City of Portland, Maine - Building or Use Permit Application
 389 Congress Street, 04101 Tel: (207) 874-8703, Fax: (207) 874-8716

**CITY OF PORTLAND, ME
BOCA 1999 Plan Review Record
One and Two Family Dwelling**

Building Description: Single Family dwelling/attached garage.

NEW RESIDENCE FOR:
WALPE RESIDENCE
PORTLAND, MAINE

*Reduced
Plans
Scale
not
shown*
REAR ELEVATION
SCALE: 1/4" = 1' - 0"

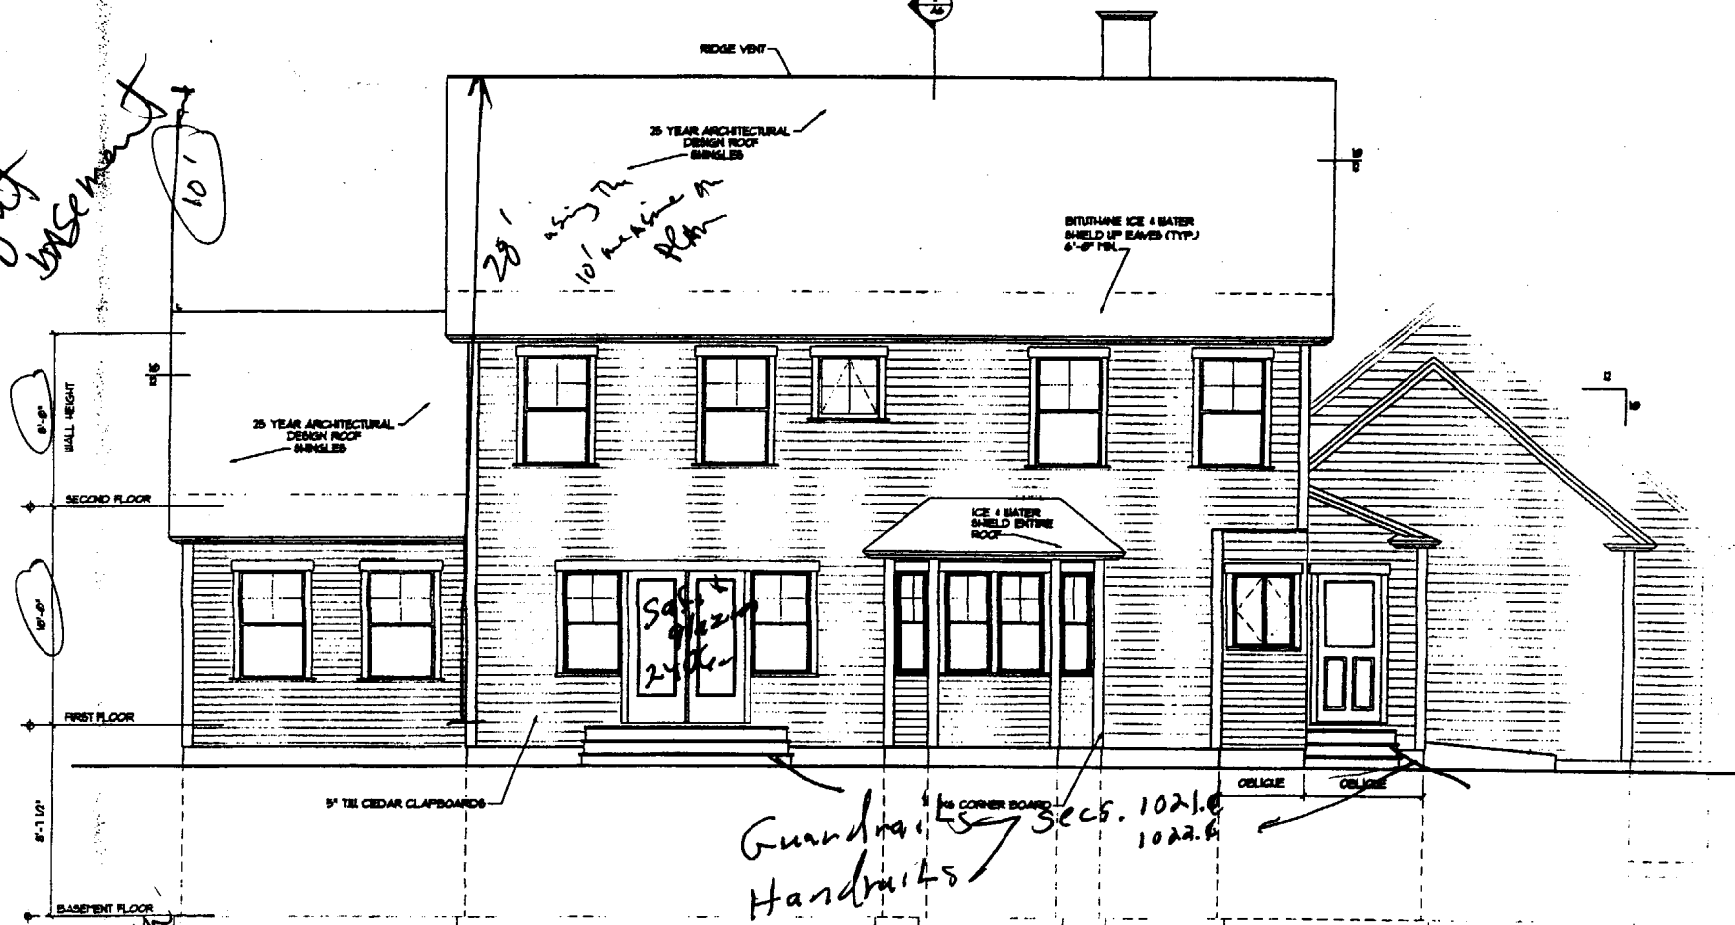
*No Drylight
basement*

*Guardrails
Handrails*
